From: "Paul Gunter" <pgunter@nirs.org>
To: <hga@nrc.gov>
Date: 07/26/2006 3:22:27 PM
Subject: Interim staff guidance on AMR of embedded steel containment at Oyster Creek

Attached please find a letter from NIRS to NRC regarding the development of interim staff guidance on the Age Management Review of corrosion in the inaccessible and embedded region of the steel drywell liner at Oyster Creek nuclear generating station and other GE MARK I Boiling Water Reactors.

Subject: Oyster Creek, Drywell Liner
Embedded Region Issues

Schematic Cross Section through Sandbed Area

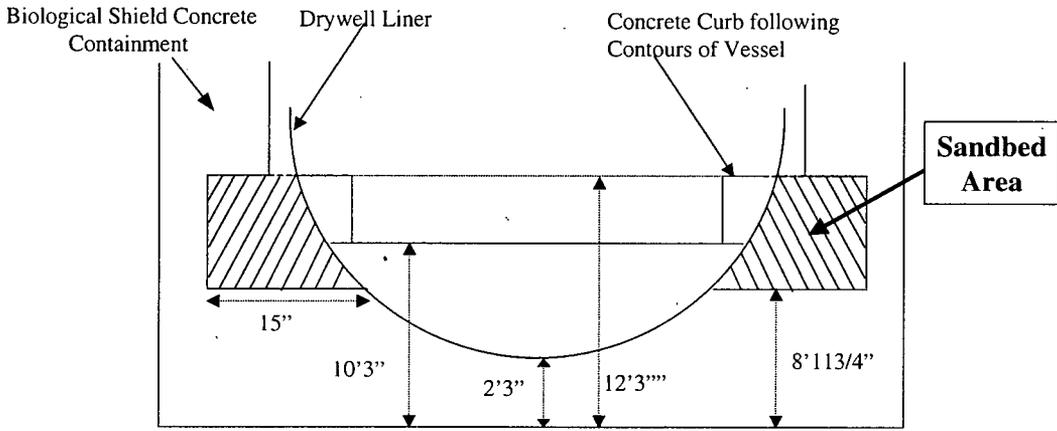
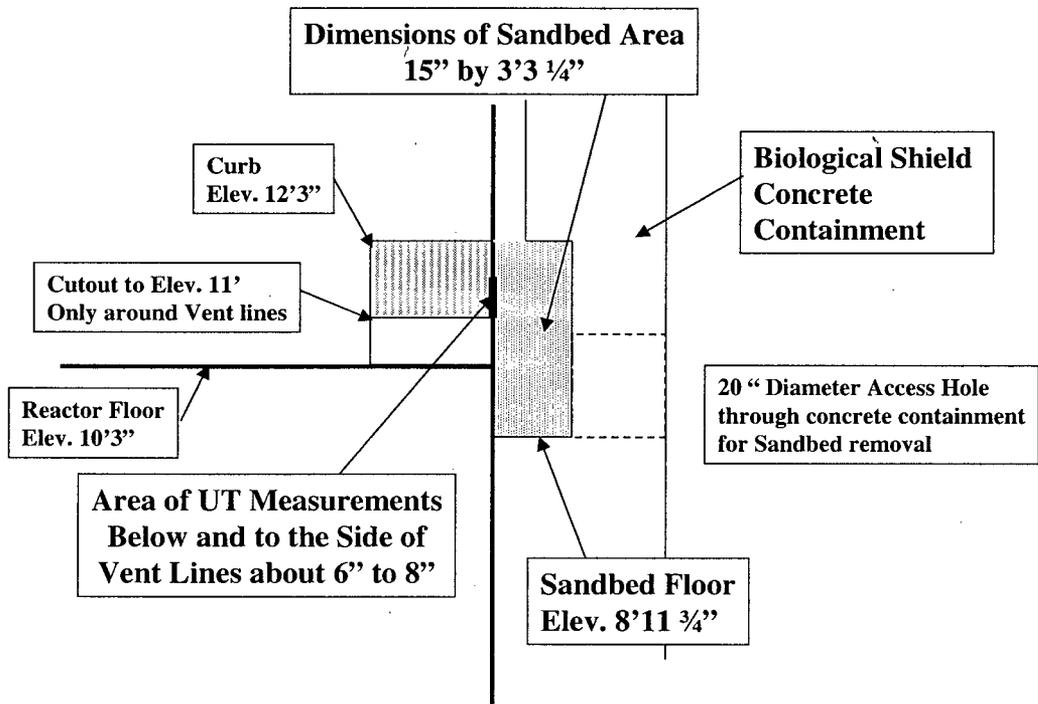
Figures 1 and 2 are sketches of the location of the sandbed area and its dimensions (Fig. 2). In view of the small access hole (20" diameter) and the even smaller sandbed dimensions (15" wide) and the resulting very confined work area one needs to wonder just how effective the repairs of the concrete floor and subsequent coating and sealing of the crevice might have been. Similarly, considering the extension of the sandbed area of 5 to 7 feet either side of the access hole, and its narrowness, one needs to ask just how thorough visual inspection can really be.

Furthermore, it was also assumed that water on concrete floor would come from above. The question of water seepage from below has never been considered or verified, another EPRI requirement, which was disregarded. As an aside, the possibility of groundwater affecting the embedded region also prompts the concern that water leaks could have reached the groundwater. If the leaking water were radioactive, this would be a major concern.

Formation of Crevice underneath Screw-head

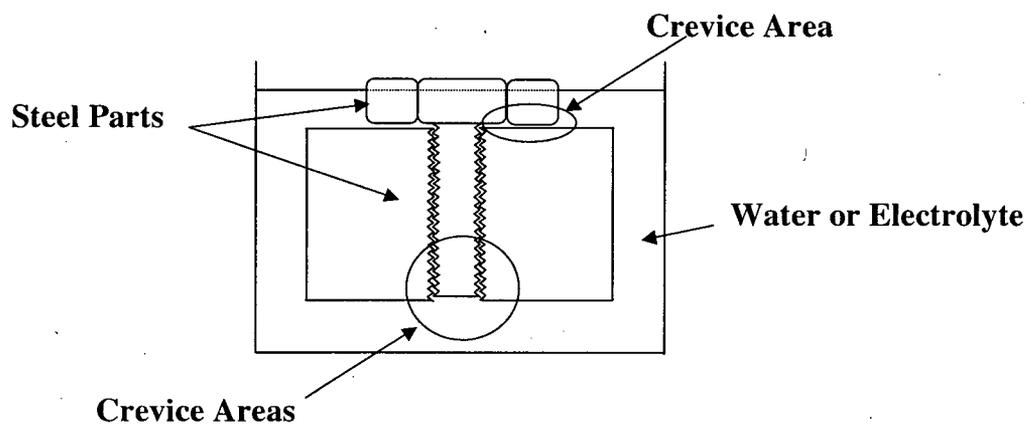
The differential aeration cell consists of a piece of iron of which one part is in contact with aerated water (or solution) while the other part is in contact with deaerated water. This situation can occur in various ways. For instance a bolt screwed into a piece of iron (Fig. AI-1) can create a crevice underneath the bolt head or in the threads where water can seep in. Another example might be a ground rod sticking into mud or indeed a metal plate in contact with wetted sand. In all these instances part of the metal is in contact with water containing oxygen (fully aerated) and metal where oxygen has difficulties to get to.
